MIL-M-28787/291A
AMENDMENT 1
31 December 1992

MODULES, STANDARD ELECTRONIC

DECODER, DIGITAL, KEY CODE AFA

FIGURE 22. Power supply filter and input capacitance test circuit for tables XVII and XVIII.

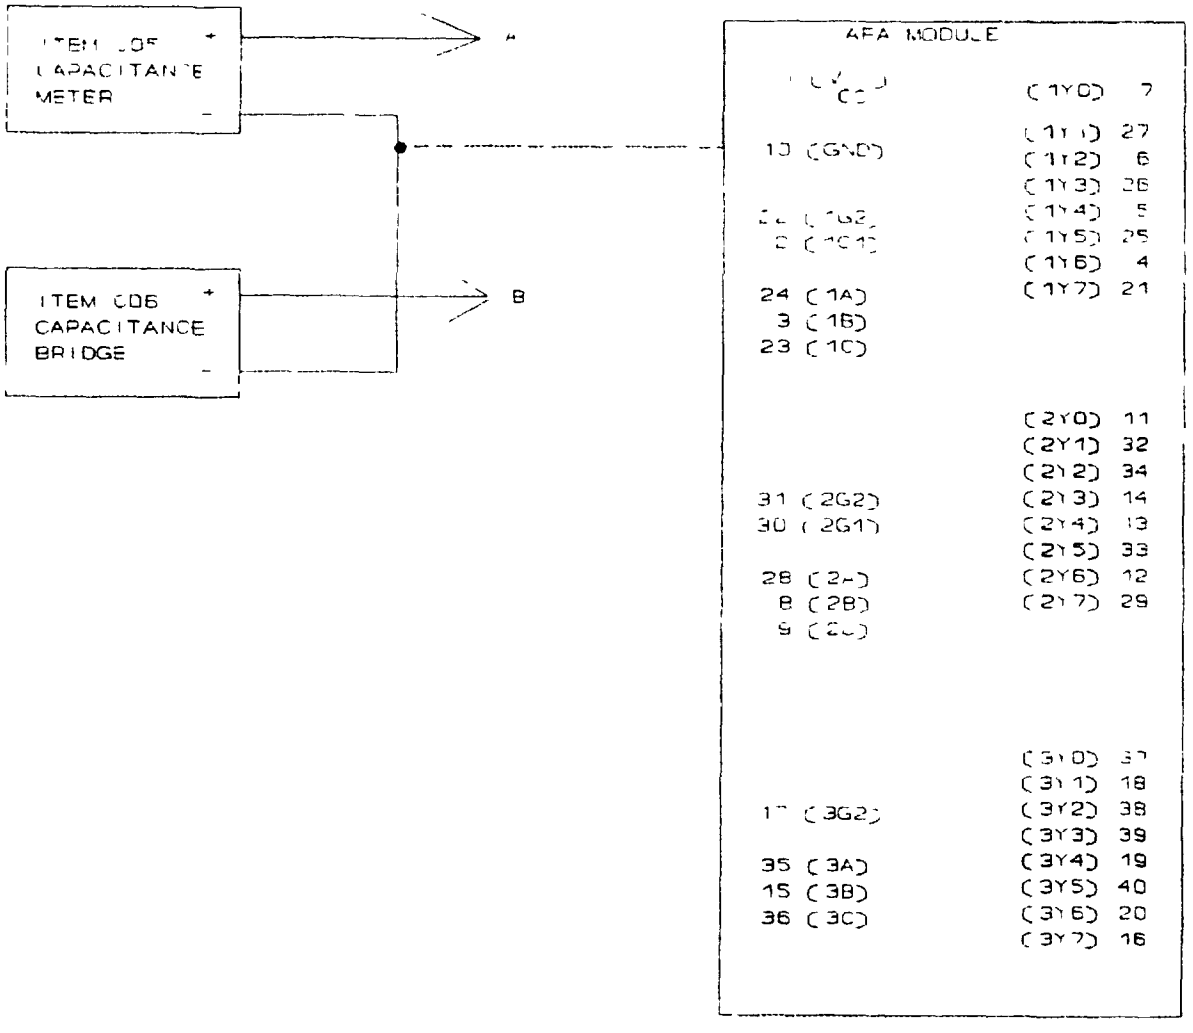
FIGURE 22: Delete and substitute new figure 22 as printed on page 3 of this amendment.

NOTES:

1. Null out the effects of the test leads prior to connecting the module.

2. Do not attach test connector or wires to any of the module pins other than pin 10 and the pin under test. Stray capacitance added to other pins may affect the readings.

3. Item C06 setup: Frequency = 1 KHz
   V_{pk} = 0.3 V maximum.
